ADDENDUM NO. ONE  
GREATER HEIGHTS ACADEMY –  
FOUR CLASSROOM ADDITION  
Page 1 of 1 (write up only)

April 22, 2015

ADDENDUM NO. ONE to the plans and specifications for the GREATER HEIGHTS ACADEMY – FOUR CLASSROOM ADDITION, Flint, MI, Architect's Project No. 141601, dated March 31, 2015.

REMOVAL  
PLAN

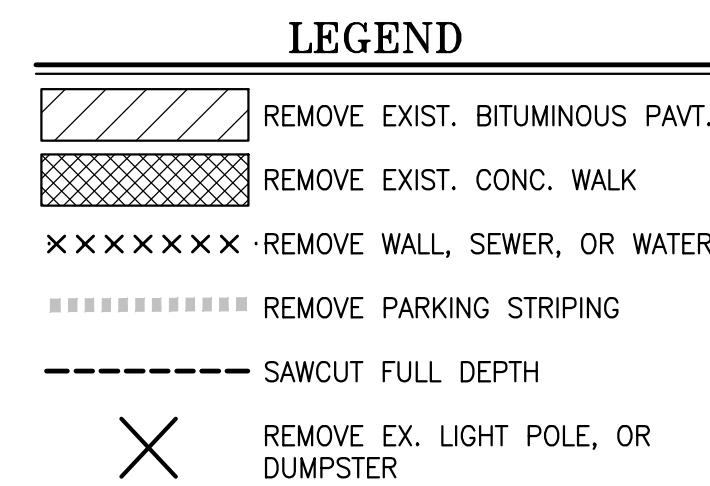
**ITEM NO. C2** Refer to Drawing C2.0 (issued).  
1. Added reference to drawing C4.0 for water main removal limits note.  
2. Updated removal limits at the south east corner of the parking area.  
3. Updated striping removal at the handicap parking entrance.

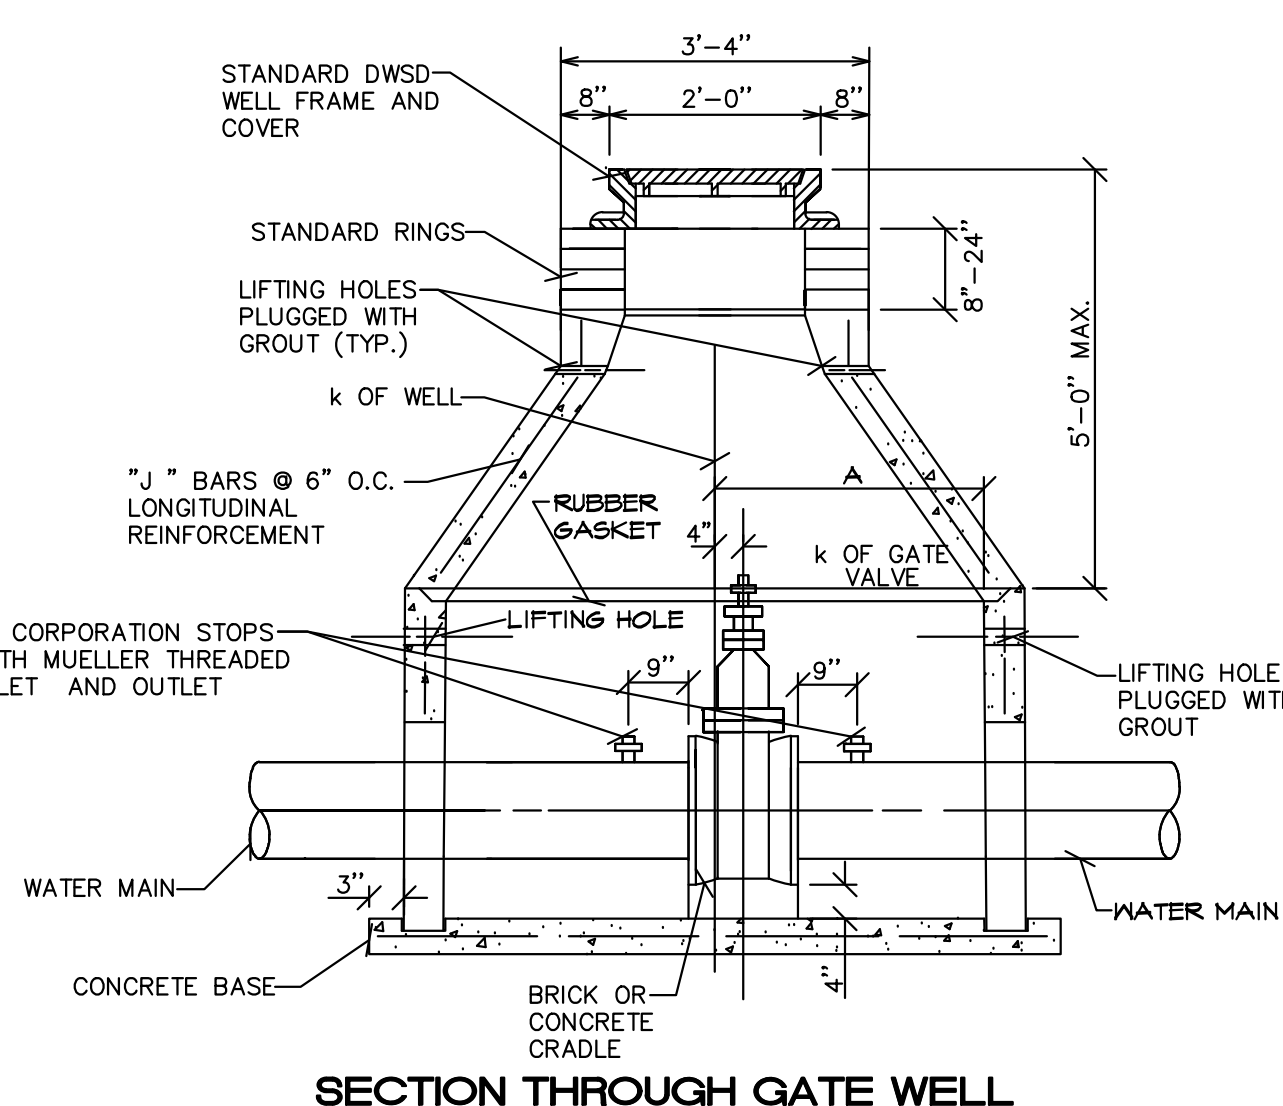
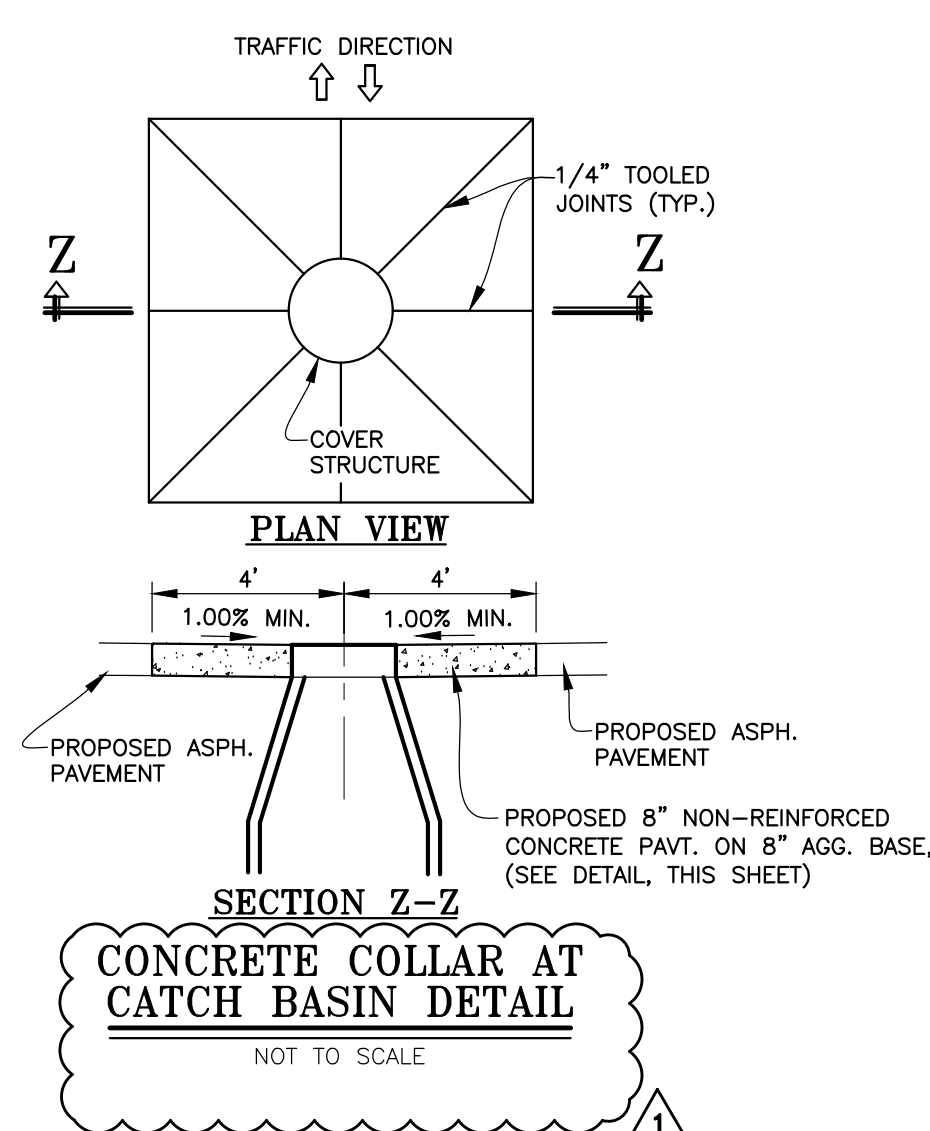
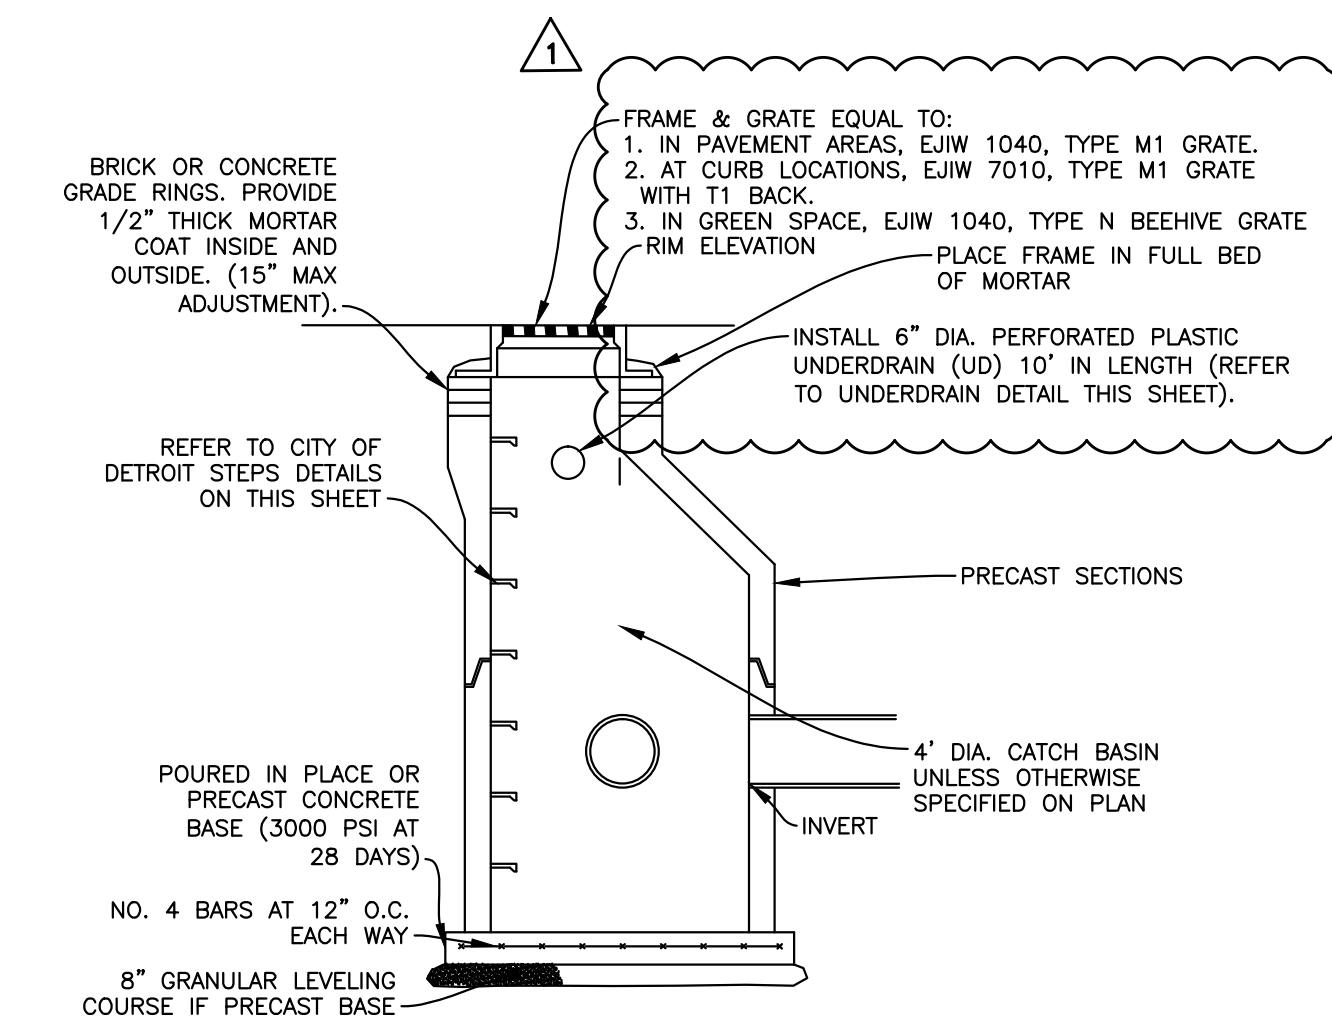
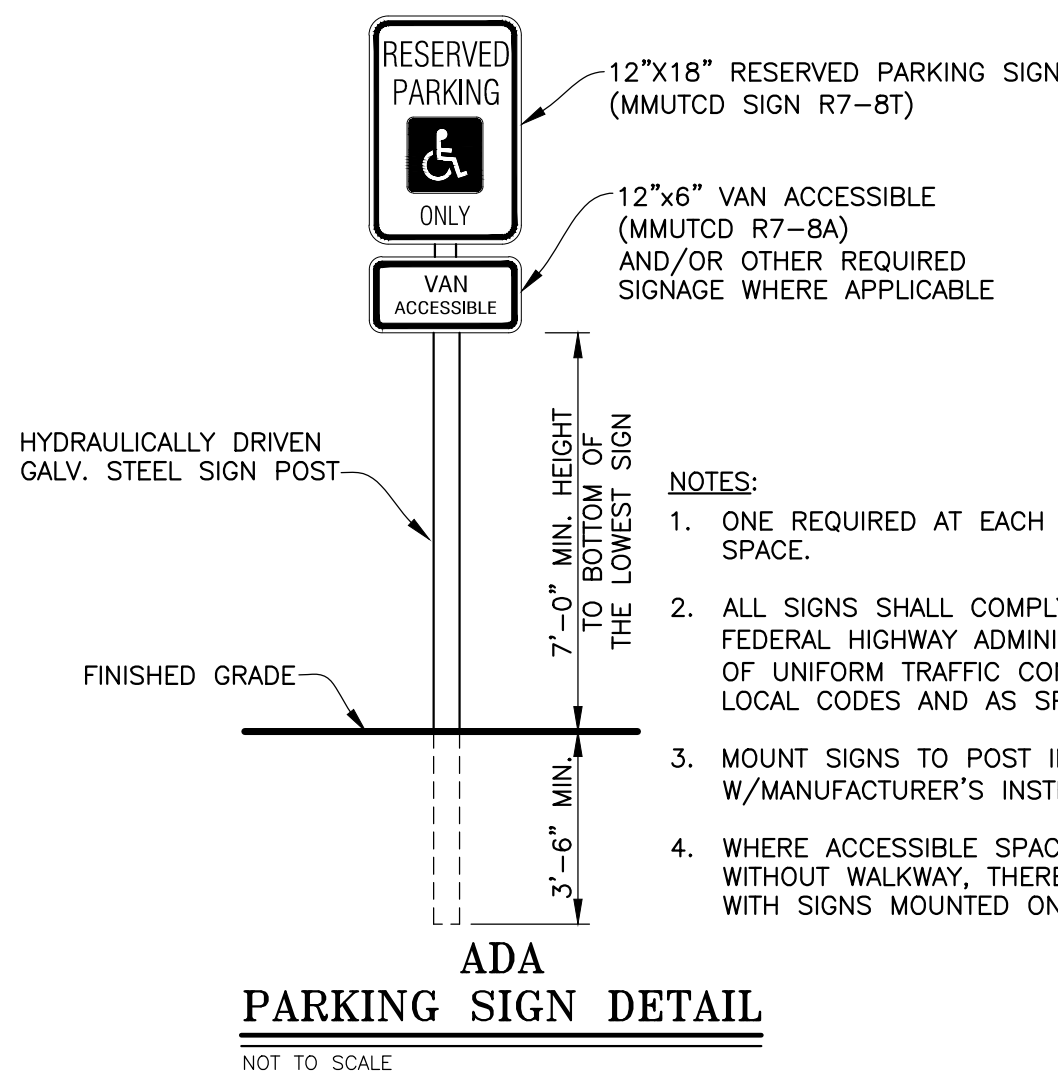
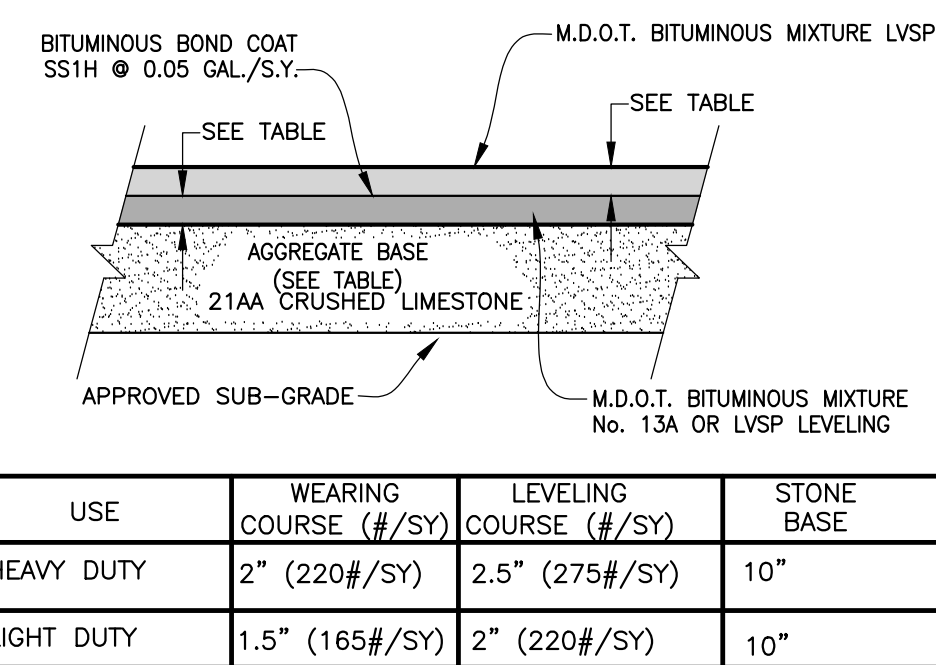
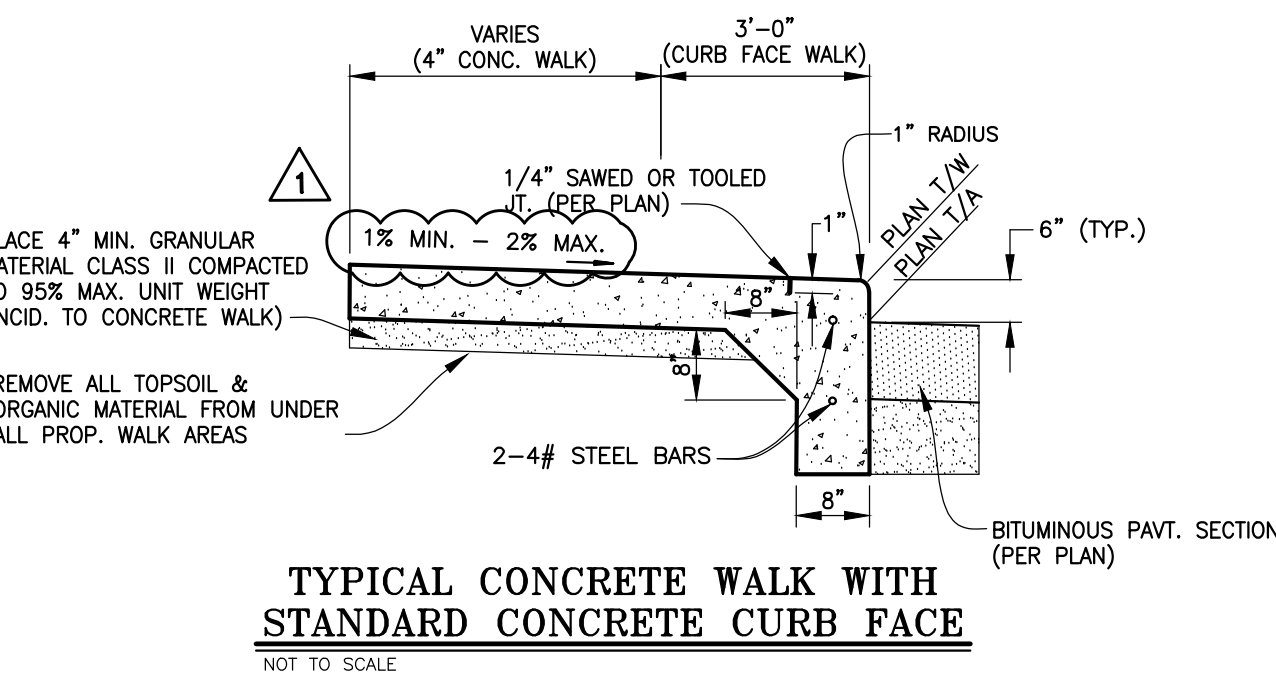
1. Updated name of the Concrete Collar detail.
2. Removed Ramp Detail from sheet.
3. Removed trench detail from the plan, drawing C4.0 references the appropriate MDOT detail.
4. Added beehive grate to catch basin detail.
5. Updated expansion joint filler thickness.
6. Updated maximum and minimum slopes for concrete walk detail.

## PARTIAL ROOF FRAMING PLAN

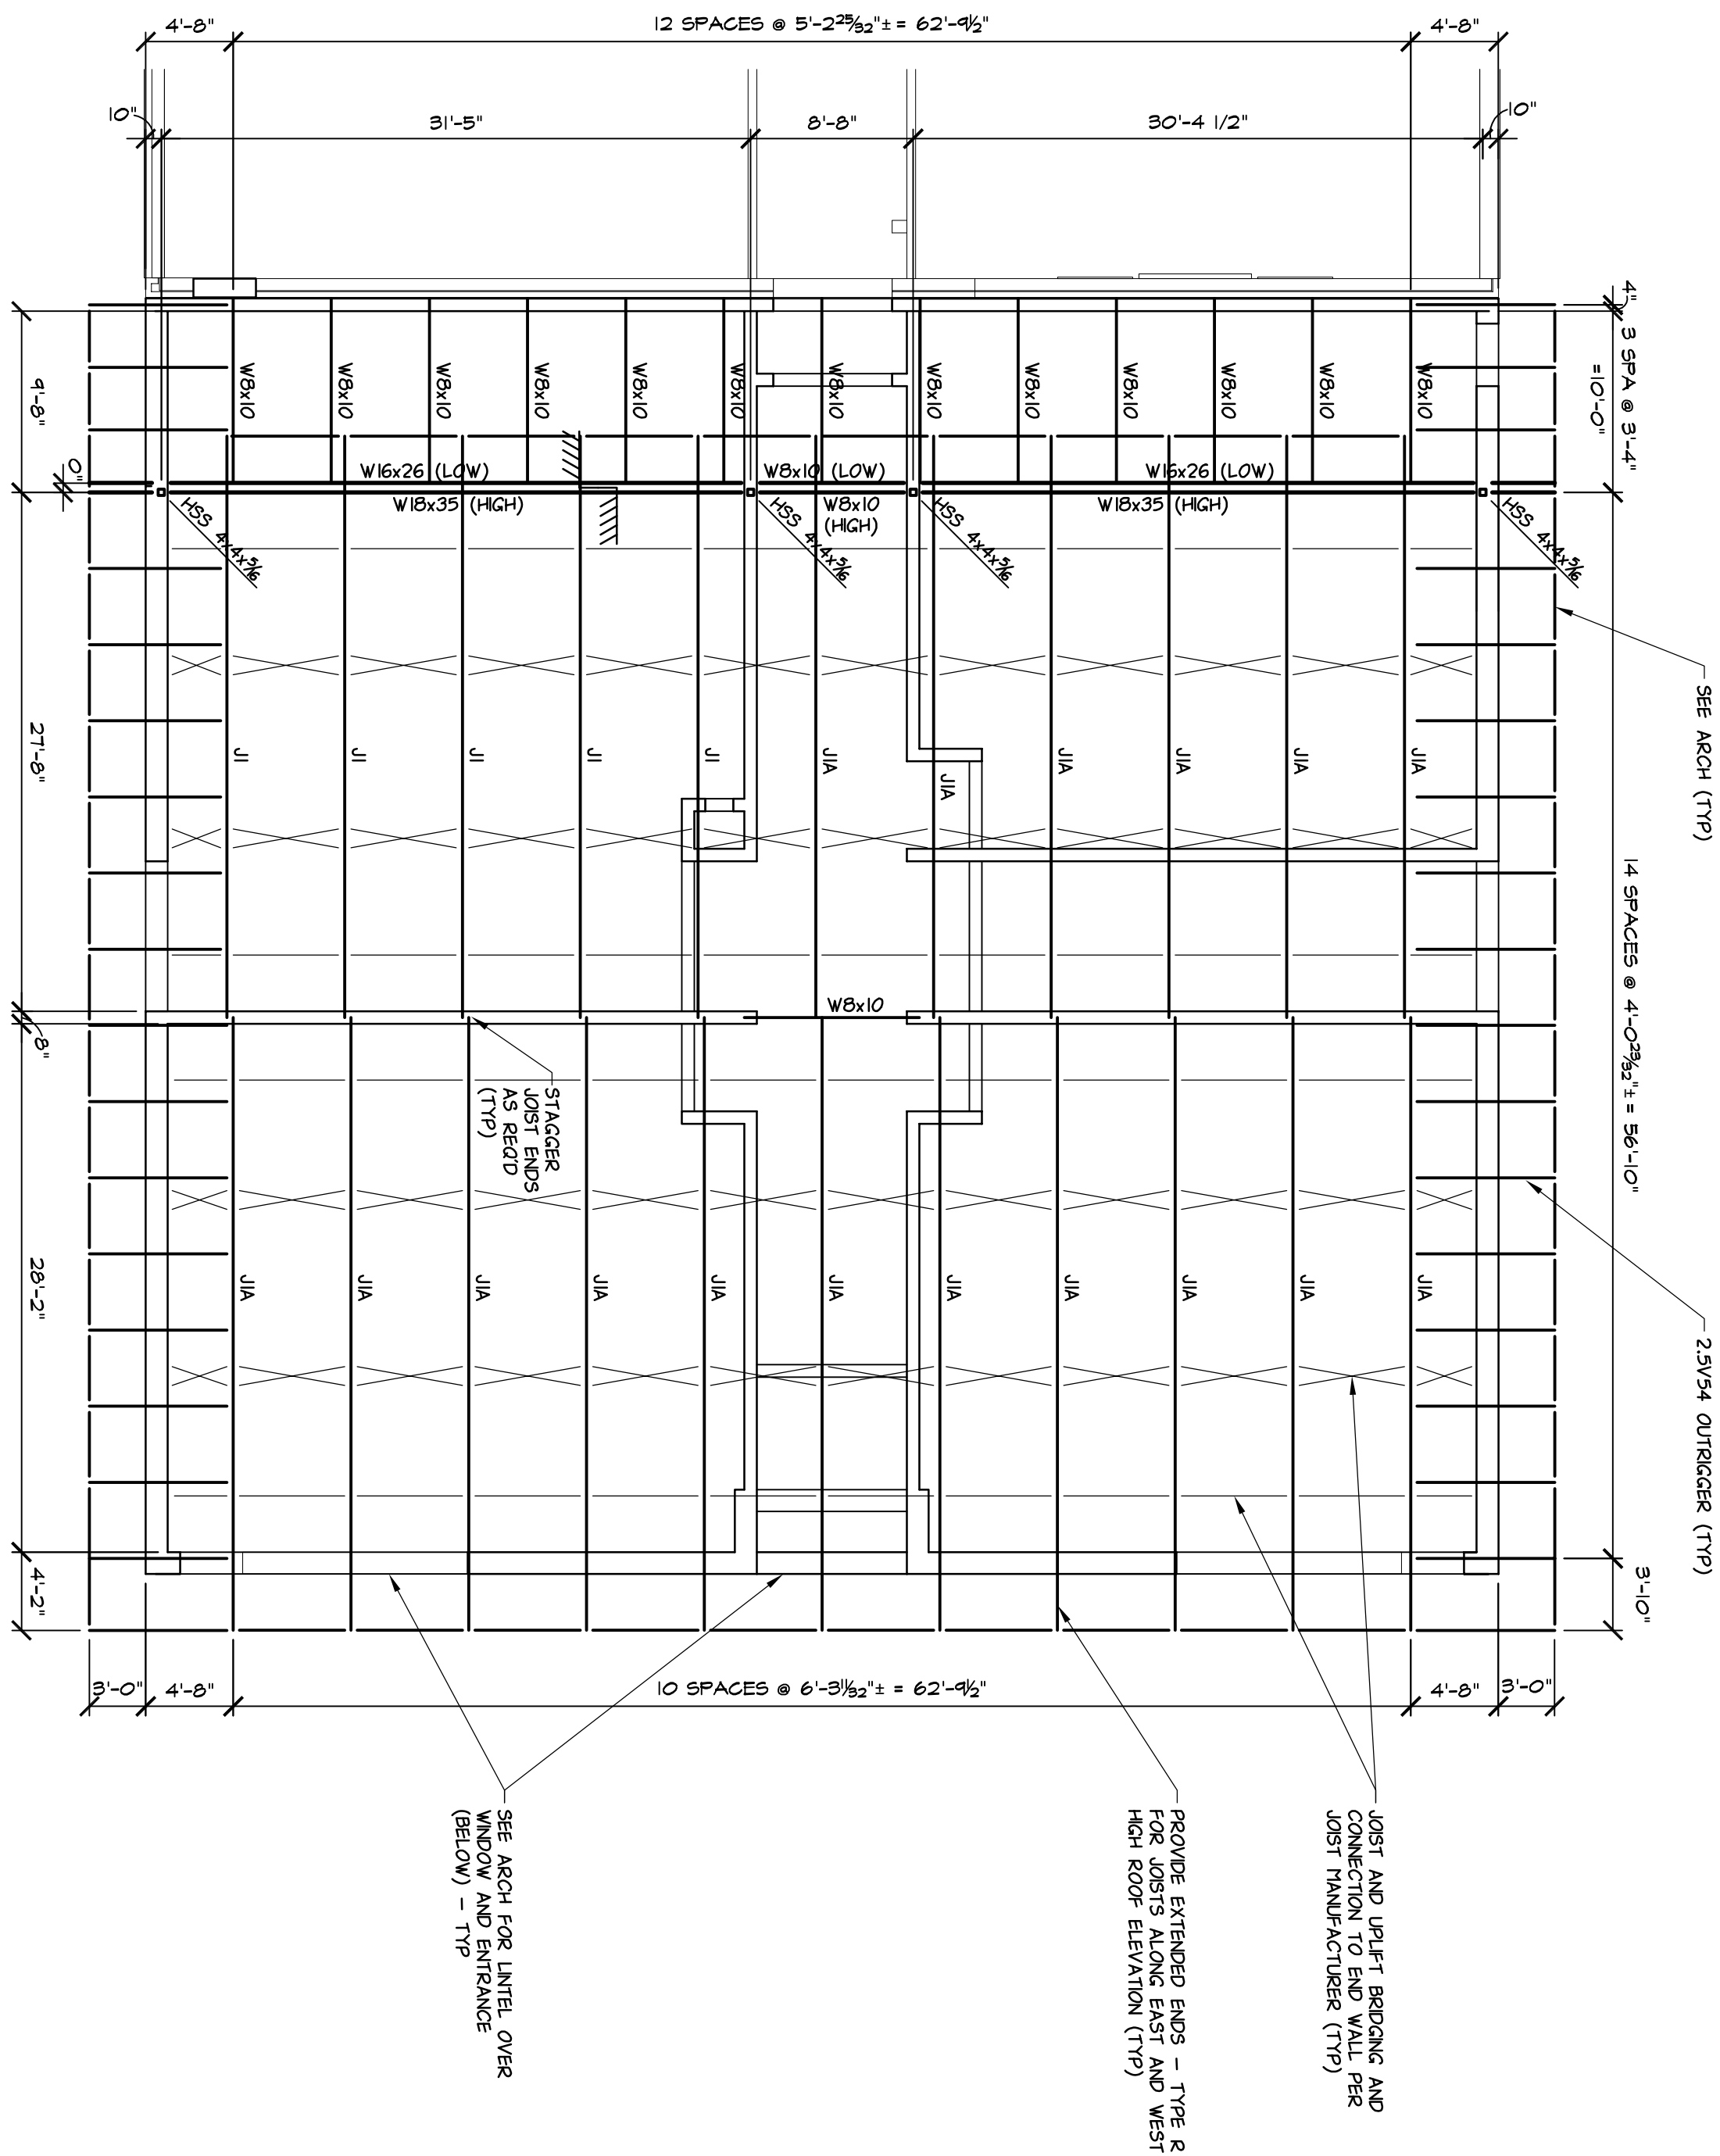
1. Partial Roof Framing Plan: Added W8x10 steel beam in Corridor 150, at top of wall between Intervention 152 and Classroom 153 and Classroom 155 and Classroom 156.
2. Partial Roof Framing Plan, Note 5: Added joist chord radius of 458'-7 1/4".
3. Partial Roof Framing Plan: Added CMU lintel at east wall, east of Door 154, per detail on Sketch A01-SK-5.
4. Partial Roof Framing Plan: Added CMU bond beam per Detail on Sketch A01-SK-4.
5. Partial Roof Framing Plan: Revised deck span at outriggers to match rest of deck span on curved roof.
